**COUNTY OF VENTURA
PUBLIC WORKS AGENCY
WATERSHED PROTECTION DISTRICT
ZONE 1
URBAN LID RETROFIT
AT MEINERS OAKS**

RECORD DRAWING

URBAN LID RETROFIT AT MEINERS OAKS
GENERAL PLAN

MODIFIED CATCH BASIN AND LOCAL DEPRESSION DETAIL
SCALE: 1" = 2'

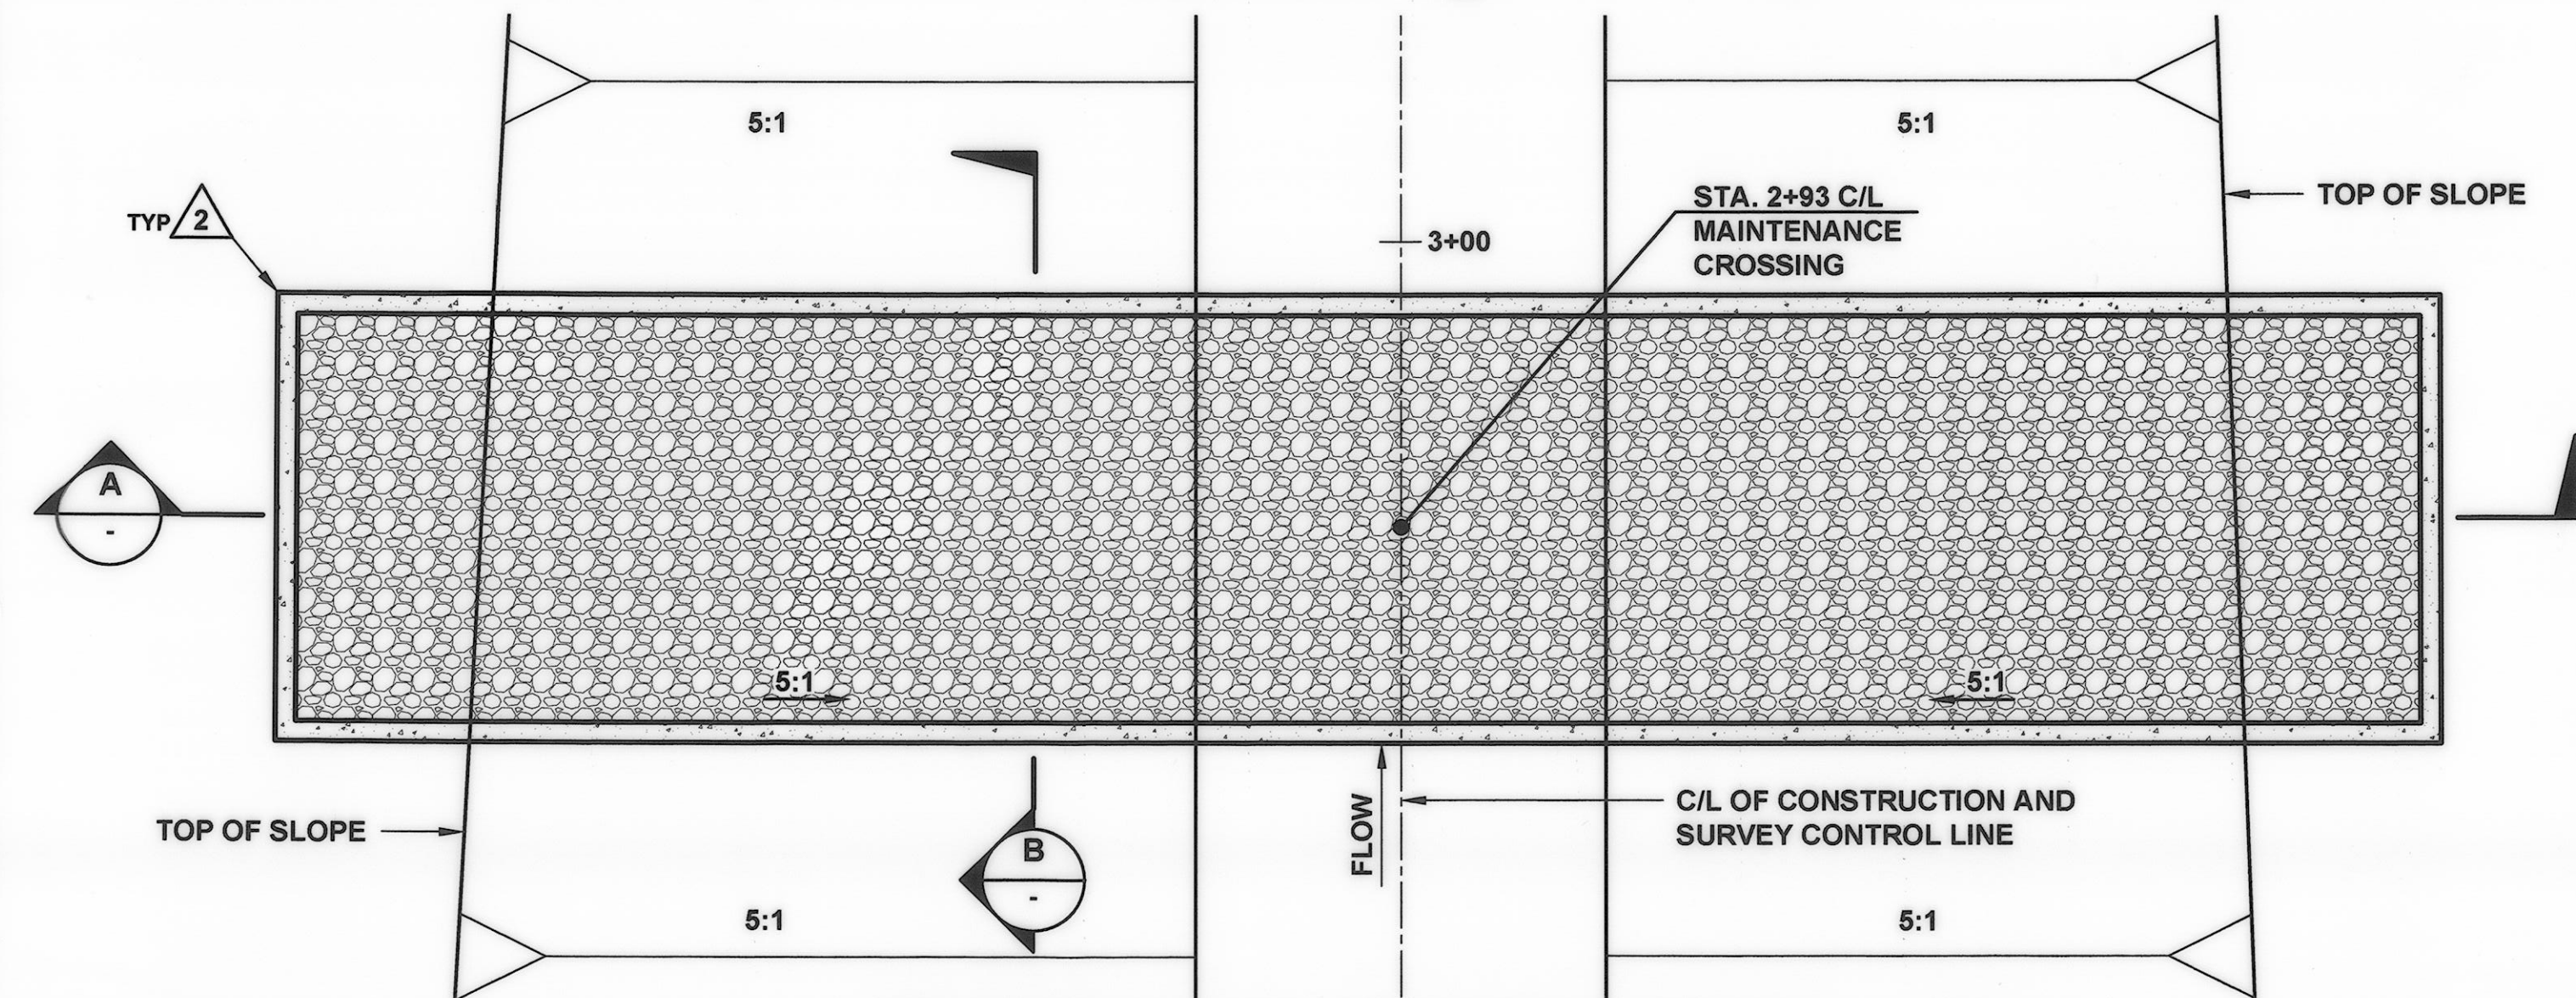
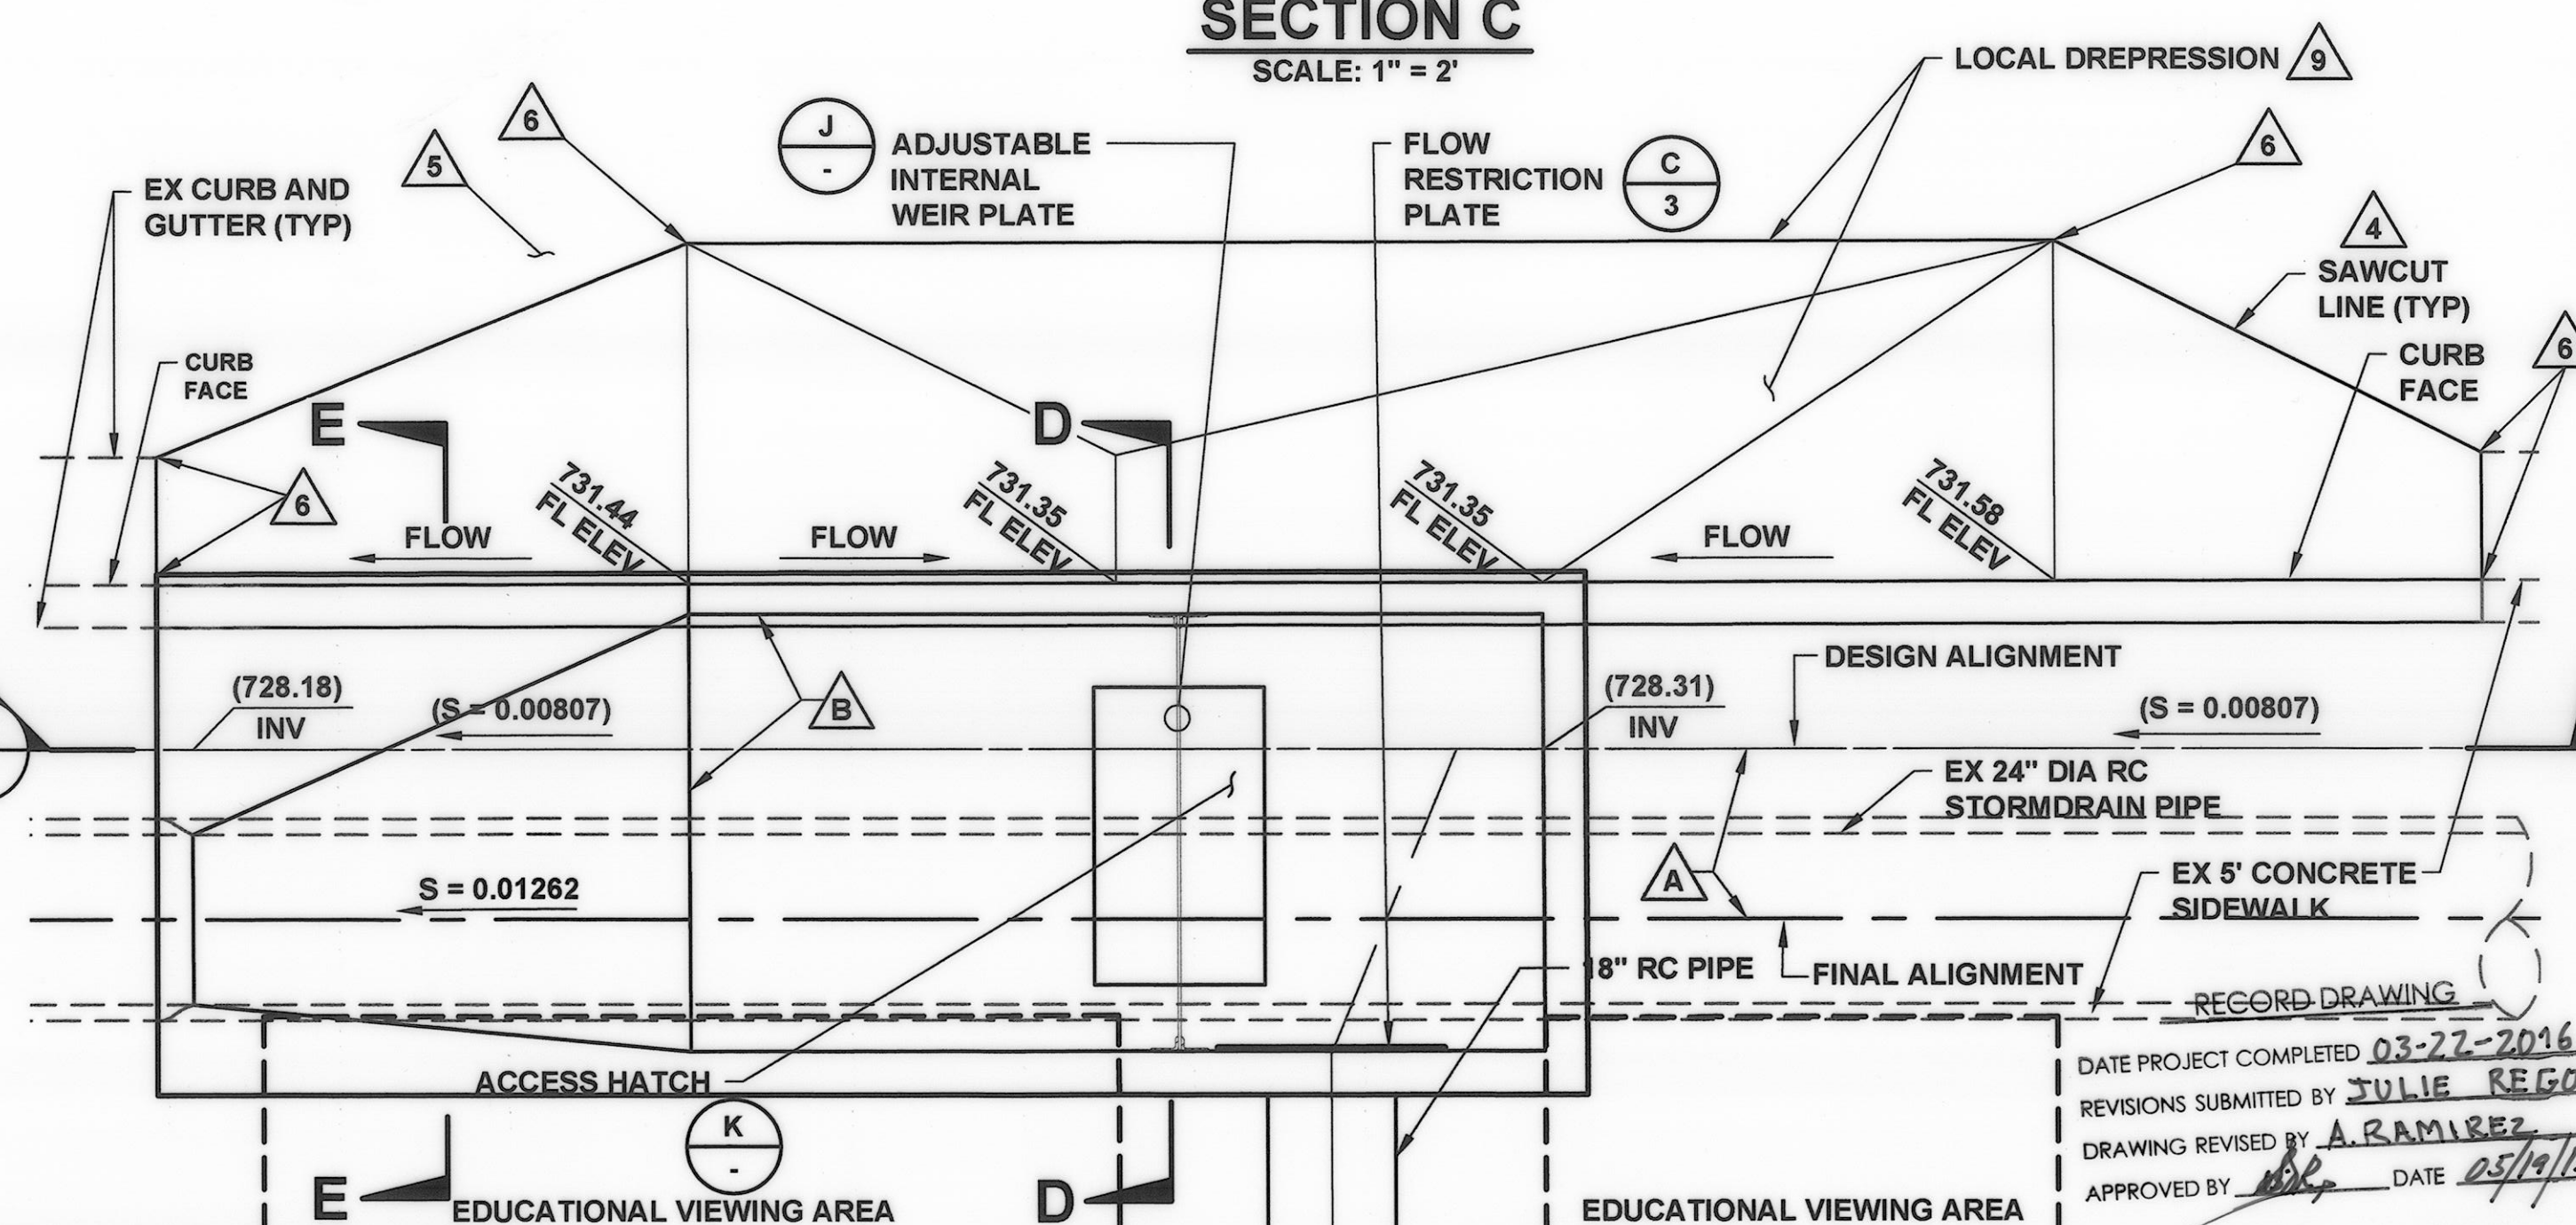
REVISION	DESCRIPTION	APP.	DATE
B	MODIFIED CATCH BASIN & TRANSITION		
A	STRUCTURE WIDENED 2 FT DUE TO EXISTING ALIGNMENT (CCO#3).		
	6" OF PIPE FOUND TO BE 2FT EAST, OF ALIGNMENT, AS SHOWN ON THE PLANS.
